EAST ELEVATION / EAST ANNEX

HIGHFIELDS WHEMPSTEAD ROAD WHEMPSTEAD – WARE – SG12 0PG	ALP ARIKOGLU RIBA Chartered Architect	
PROPOSED REPLACEMENT DWELLING REVISED PLANNING SET	Kimpton Mill Codicote Hertfordshire SG4 8ST	Tel 07973 221 618 email alp@arikoglu.co.uk
REVISED EAST ELEVATION HOUSE AND SIDE ANNEX	JOB: 2022102 SCALE: 1:100 @ A3	1.10-A

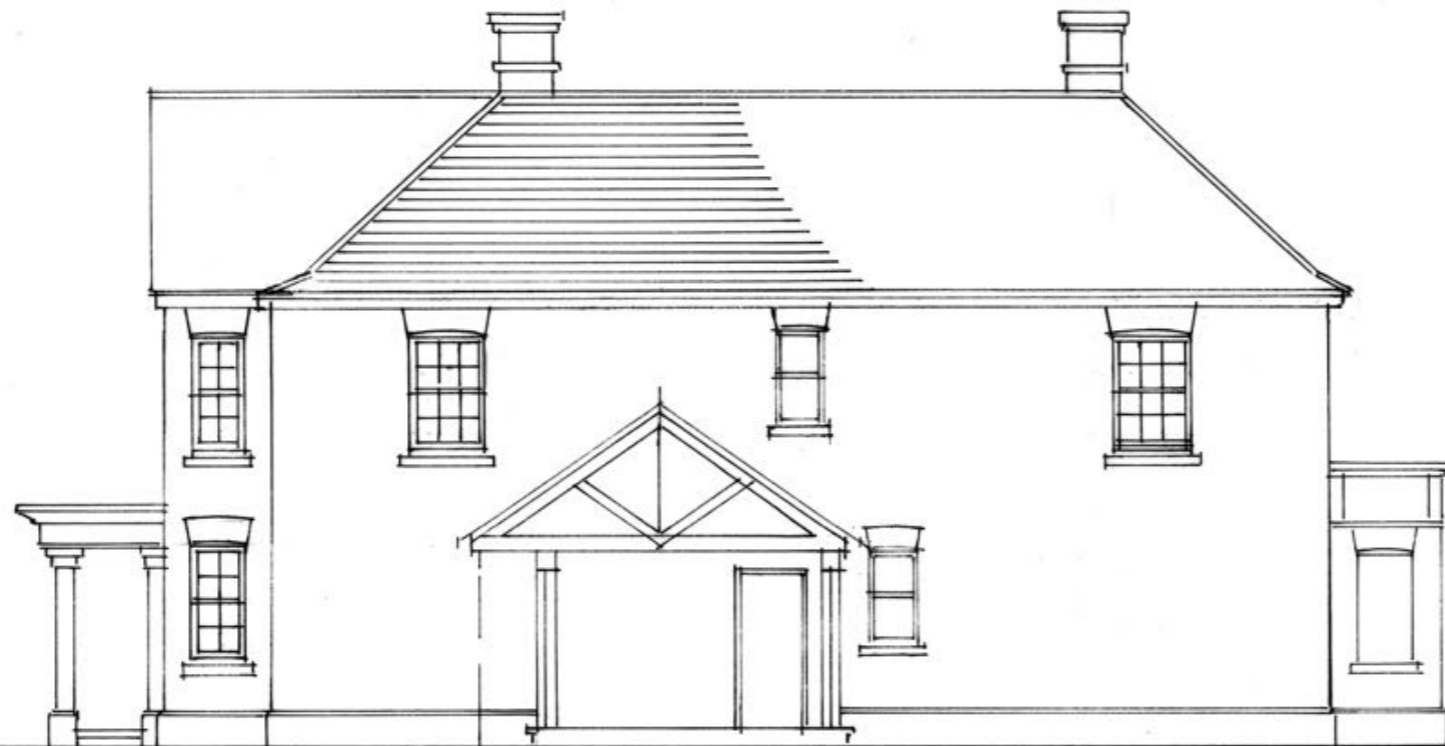
- 1: CENTRAL HIPPED ROOF CHANGED TO GABLE END
- 2: WINDOW AND FRENCH DOOR PROPORTIONS REVISED
- 3: GLAZING BARS ADDED TO ALL JOINERY
- 4: BRICK PLINTH ALTERED TO LIMESTONE TO MATCH LIMESTONE PORCH
- 5: BRICK WORK CHIMNEYS ADDED
- 6: LIMESTONE CILLS ADDED
- 7: WINDOW ARCHES REVISED TO CAMBERED GAUGED ARCHES
- 8: FIRST FLOOR SIDE WINDOW ADDED TO BEDROOM 4
